NAVSHIPS 0967-066-7190

ELECTRONICS FIELD CHANGE BULLETIN
NAVAL SHIP SYSTEMS COMMAND
DEPARTMENT OF THE NAVY
WASHINGTON, D.C. 20360

12-, 15-, 16-, 18-, 19-, 20-, 21-, 22-AN/URC-32
1-, 4-, 5-, 6-, 7-AN/URC-32A
2-, 3-, 4-AN/URC-32B
3-, 6-, 7-, 9-, 10-, 11-, 12-, 13-KWT-6 (8)

Figure 1.

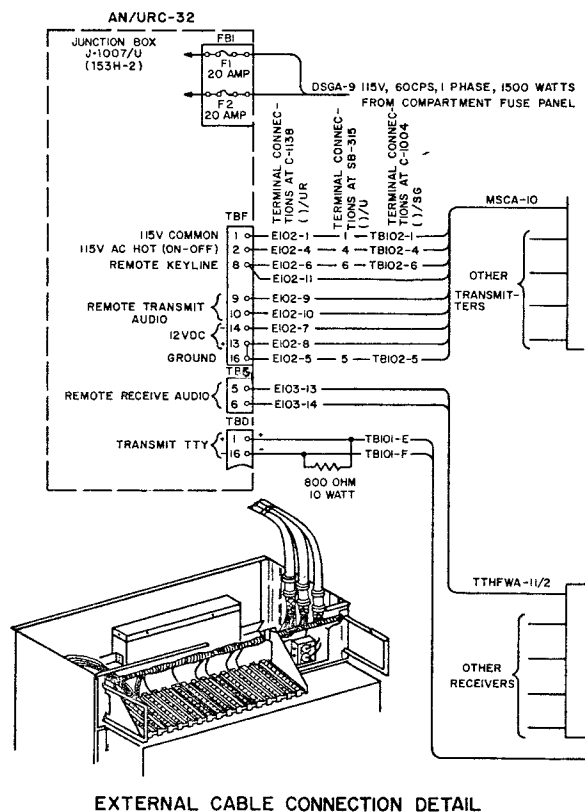
Field Change 18-AN/URC-32, 4-AN/URC-32A, 9-KWT-6/8, Junction Box (J-1007)(153H-2); Modification for 600 Ohm Output to Receiver Switchboard System—Type II, Class A; 1 Man-Hour Required

The purpose of this Field Change is to provide a 600 ohm output impedance instead of a 4 ohm impedance to the receiver audio switchboard system and to bypass the "Remote-Local" switch so that the receiver audio will be present at the switchboard at all times. It is still necessary to operate the "Remote-Local" switch for transmitter control.

Difficulty has been experienced aboard ship when paralleling the AN/URC-32 with another receiver through the audio patch panel. When the AN/URC-32 receiver is switched in, the audio from the other receiver is blanked out. This difficulty is caused by using the 4 ohm output from the AN/URC-32 series of equipments.

1. Remove cover from junction box.
2. Replace the 680 ohm resistor connected across contacts 5 and 6 of terminal board "G" with an 1800 ohm 2 watt resistor.
3. Connect audio cable to remote system on contacts 5 and 6 of terminal board "G" instead of Contacts 11 and 12 on terminal board "F".

Figure 1. Receiver overload protective device before field change.

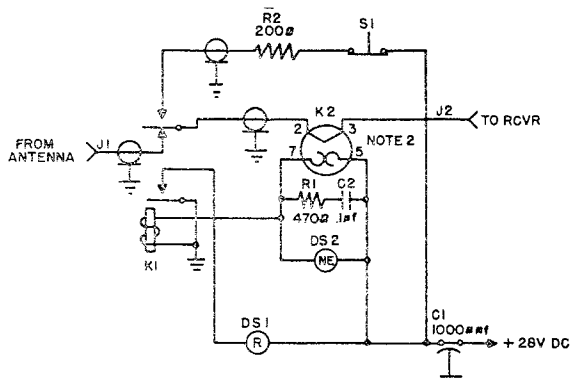
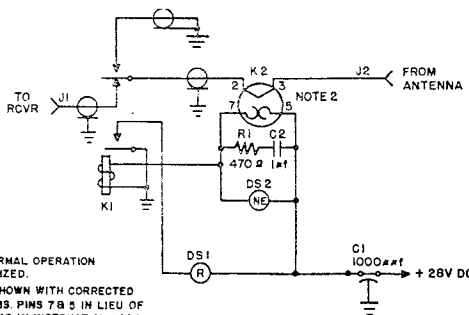
Field Change 20-AN/URC-32, 6-AN/URC-32A, 3-AN/URC-32B, 11-KWT-6(8)- Wiring Change to Receiver Overload Protective Device; Type II, Class A; 1 Man-Hour Required.

The purpose of this field change is to provide automatic reset after an overload condition.

Refer to figures 1 and 2 of this change, and proceed as follows:

4. Remove the coaxial lead connected between relay (K1) and resistor (R2) (200 ohms, 5 W, 5 percent).

5. Shorten the coaxial cable, removed in step 4, to within 1 inch of the BNC connector. Remove 1/2 inch of the outer insulation. Push the braided shield back and remove 3/8 inch of the dielectric from the center conductor. Pull the shield over the conductor and solder the conductor and shield together.

6. Connect the grounded BNC connector to K1 as removed in step 4. Replace bottom cover.
7. Stencil "ANTENNA INPUT" adjacent to J2. Stencil "TO RECEIVER" adjacent to J1.
8. Reinstall the protective device in the AN/URC-32. Connect leads removed in step 2 (Cable W-27 or antenna cable will connect to J2, Cable W-3 will connect to J1).
9. Return equipment to normal operation.

Figure 1. Modification performed.

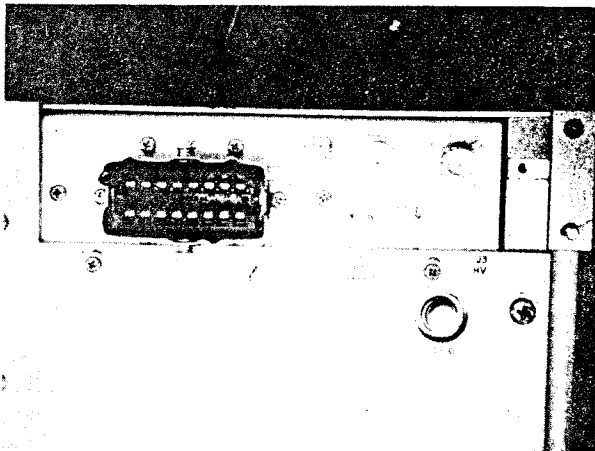
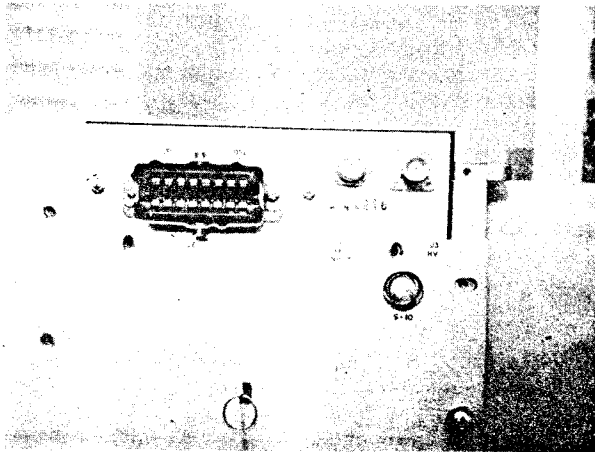
Field Change 21-AN/URC-32, 7-AN/URC-32A, 4-AN/URC-32B, 12-KWT-6(8)-Modification to the Radio Frequency Amplifier, AM-2061/URT RF Input Receptacle, 2J1, and Plug, 15W2P1; Type II, Class A; 1 Man-Hour Required

The purpose of this field change is to provide dissimilar receptacles and plugs which will prevent the inadvertent reversal of the RF input plug, 15W2P1, and high voltage plug, 15W9P1, in the Radio Frequency Amplifier, AM-2061/URT.

5. Remove 2J1, R.F. input receptacle, type UG-931/U, from the mounting bracket. NOTE: 2J1 is the center connector on the mounting bracket (see figure 1).

7. Assemble the new, DAGE No. 8009-1, connector on the coaxial cable.

8. Install the new connector, DAGE No. 8009-1, on the mounting bracket.
